**Attachment XII  
Site Specific Sampling and Analysis Plan  
Groundwater Remedial Investigation  
TNT and Red Water Ponds Areas**

**Former Plum Brook Ordnance Works, Sandusky, Ohio**

**RESPONSE TO COMMENTS  
U. S. ARMY CORPS OF ENGINEERS  
ON ATTACHMENT XII, SITE SPECIFIC SAMPLING AND ANALYSIS PLAN,  
GROUNDWATER REMEDIAL INVESTIGATION, TNT AND RED WATER  
PONDS AREAS, FORMER PLUM BROOK ORDNANCE WORKS  
SANDUSKY, OHIO  
(Draft dated June 2001)**

*Response to U. S. Army Corps of Engineers on Attachment XII  
Comments from CELRN-EC-R-D, June 2001.*

**FIGURE 1-2**  
LOCATIONS OF AREAS OF CONCERN

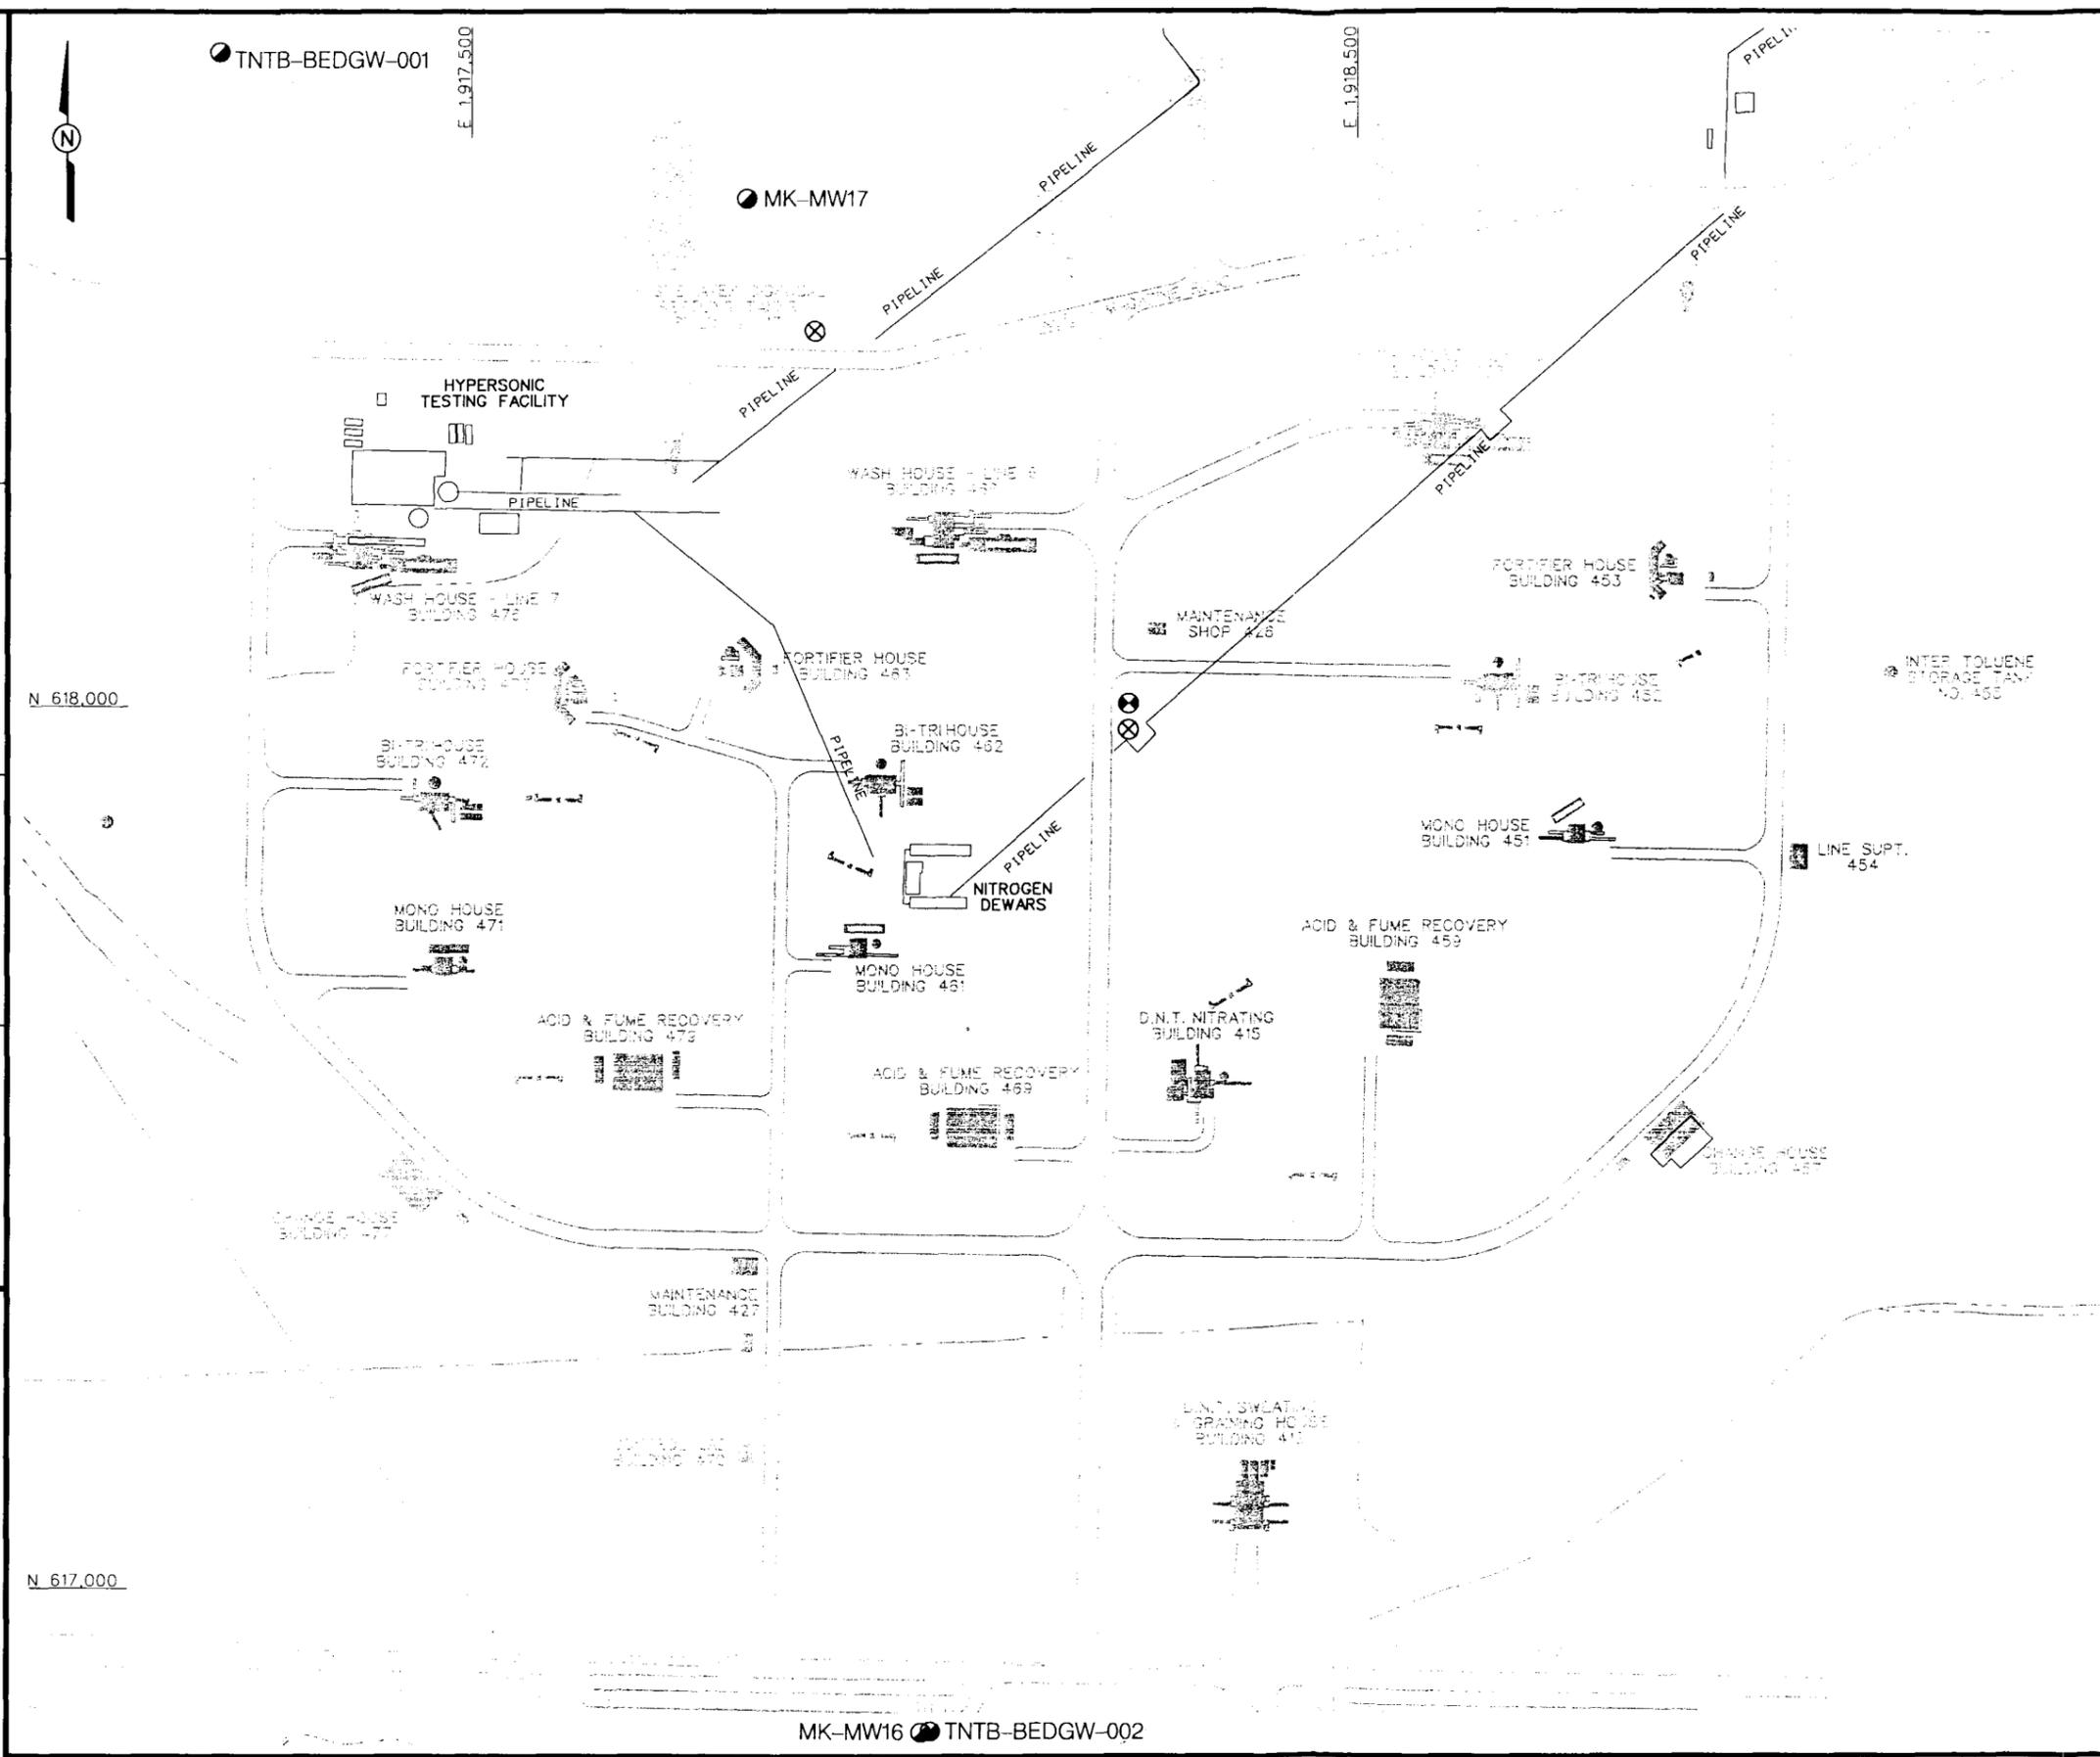
**Comment 13:** **Figure 1-2: The new bedrock well expected to go in on the upgradient boundary southeast of TNT Area B was not displayed.**

**Comment 14:** **Figures 1-2, 1-3, 1-4, 1-5, and 1-6: In the legend, rather than "Proposed Piezometer" use "Proposed Overburden". Also, since we're only showing potential locations for the new overburden wells that will be paired with a bedrock one maybe we should add a "Note" explaining that each TNT Area will also get 4 new overburden wells, their locations to be based on the direct push sampling.**

**Response 13:** According to the Scope of Work, Table 2, the additional bedrock well should be installed southwest of the TNT B area. An additional bedrock well has been added to Figure 1-2 to reflect the scope of work.

- Response 14:** Noted, changes to Figures 1-2 through 1-6 have been made to reflect these comments.
- Comment 15:** **Figure 1-5: Please add the location of soil boring DP-13 at the WARWP and adjust the legend as necessary.**

**FIGURE 1-6**  
 TNT AREA C GENERAL SITE  
 FEATURES AND PROPOSED  
 MONITORING WELL LOCATION MAP  
 FORMER PLUM BROOK ORDNANCE WORKS  
 NASA PLUM BROOK STATION  
 SANDUSKY, OHIO

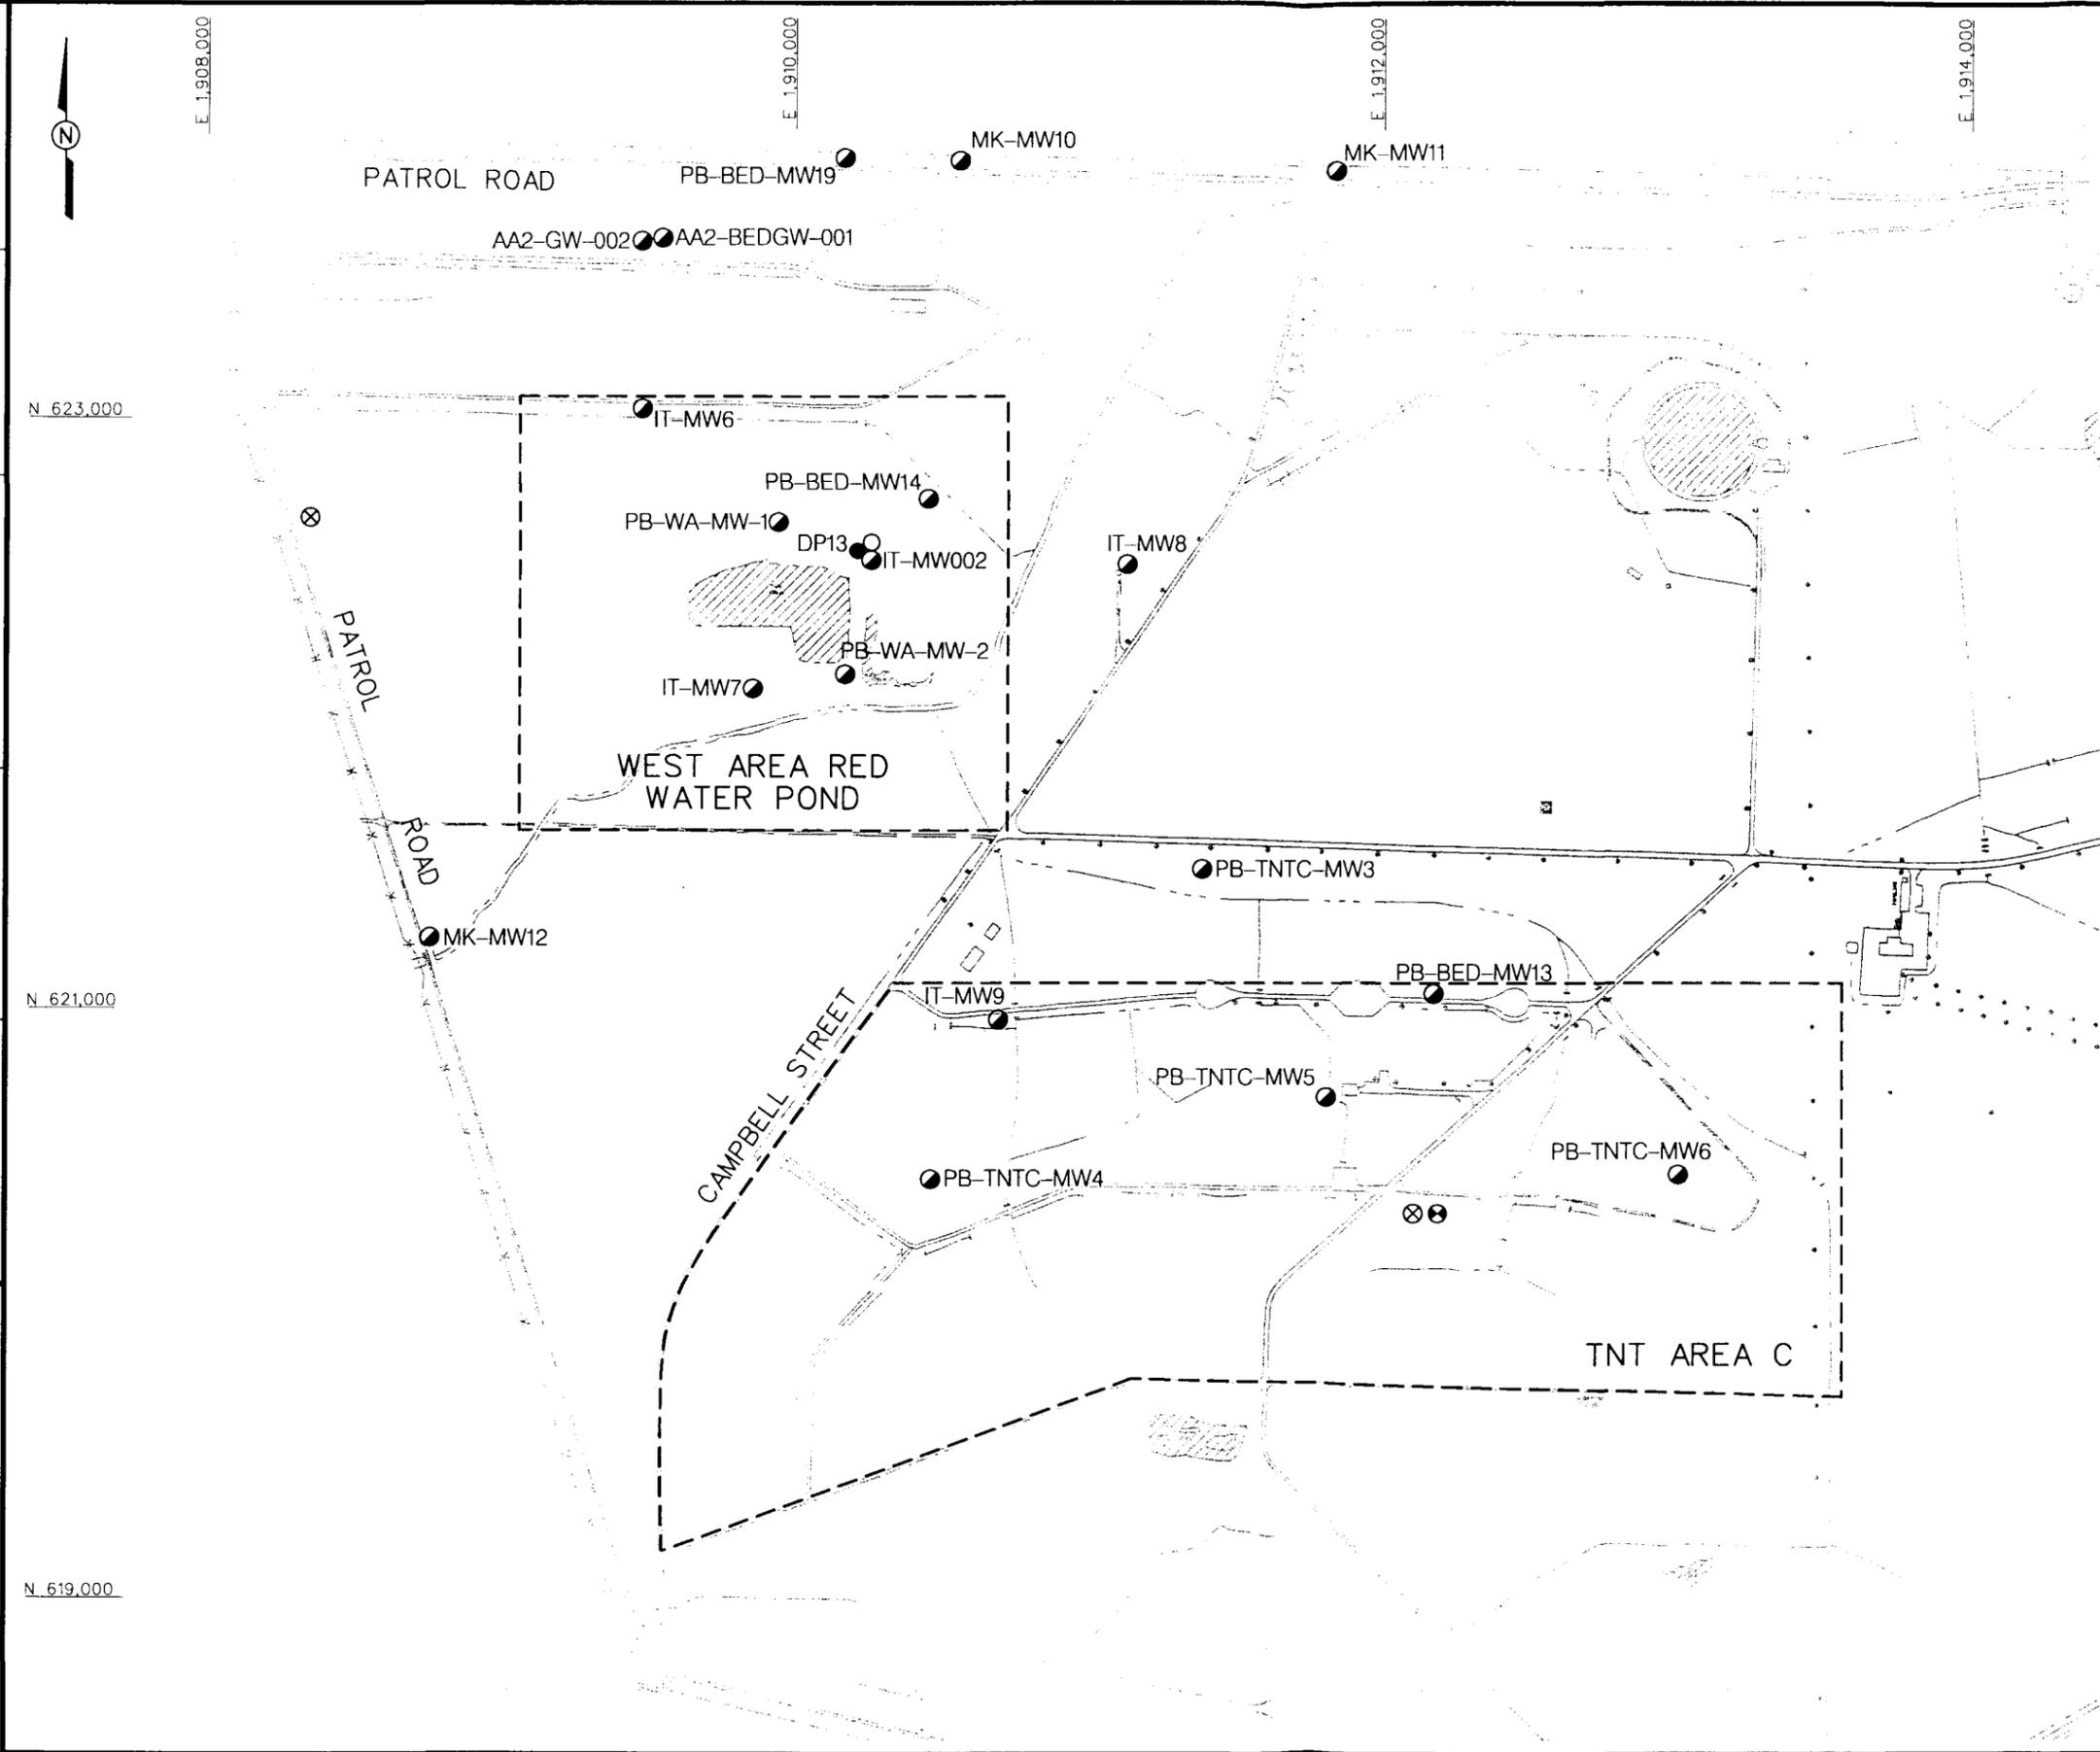
- Comment 1:** Page 1-6, paragraph at bottom of page: Is the location of MK-MW12 shown on any of the TNT Area C figures? I couldn't find it on Figure 1-5.

- Response 1:** MK-MW12 has been included on Figure 1-5.
- Comment 2:** Page 2-3, Section 2.4.4, last sentence: The copy of the SSAP I reviewed has no Figure 2-2. Perhaps the reference was intended to refer to the flow chart, Figure 2-1.

**FIGURE 1-5**  
**WEST AREA RED WATER PONDS**  
**AND TNT AREA C PROPOSED**  
**MONITORING WELL LOCATION MAP**  
 FORMER PLUM BROOK ORDNANCE WORKS  
 NASA PLUM BROOK STATION  
 SANDUSKY, OHIO

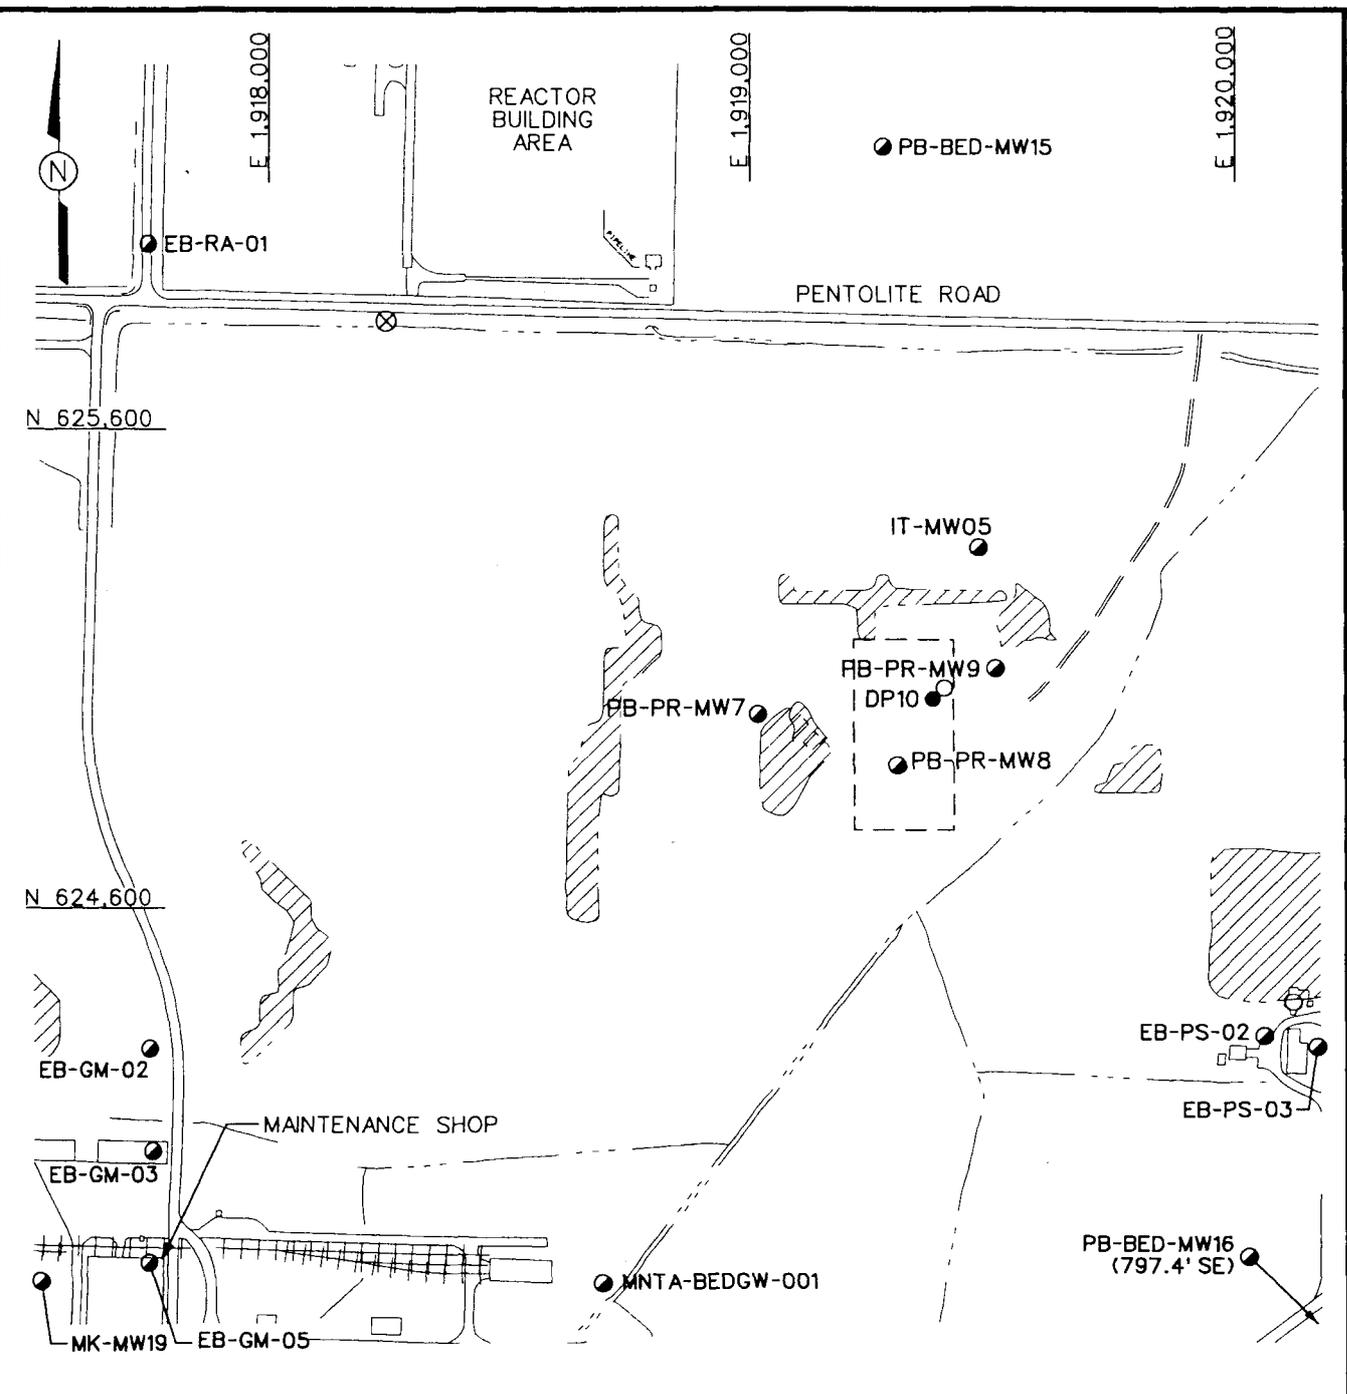
- Response 3:** Yes, the number of new and existing wells to be sampled is 23. This has been corrected in the text.
- Comment 4:** Page 3-1, Section 3.1, last sentence; page 3-3, Sections 3.2.2.1 and 3.2.2.2: I couldn't find any soil sampling locations proposed on any of the figures.

- Response 4:** Proposed soil sampling locations have been added to Figures 1-5 and 1-7.
- Comment 5:** Page 3-1, Section 3.2.1: The first sentence implies that there will be 10 bedrock wells installed at the TNT Areas but really only 4 of the 10 are to be associated with particular TNT areas. Please correct the text appropriately.

- Response 15:** Noted, the location of soil boring DP-13 has been added to Figure 1-5.
- Comment 16:** **Figure 1-7: Please add the location of soil boring DP-10 at the PRRWP and adjust the legend as necessary.**
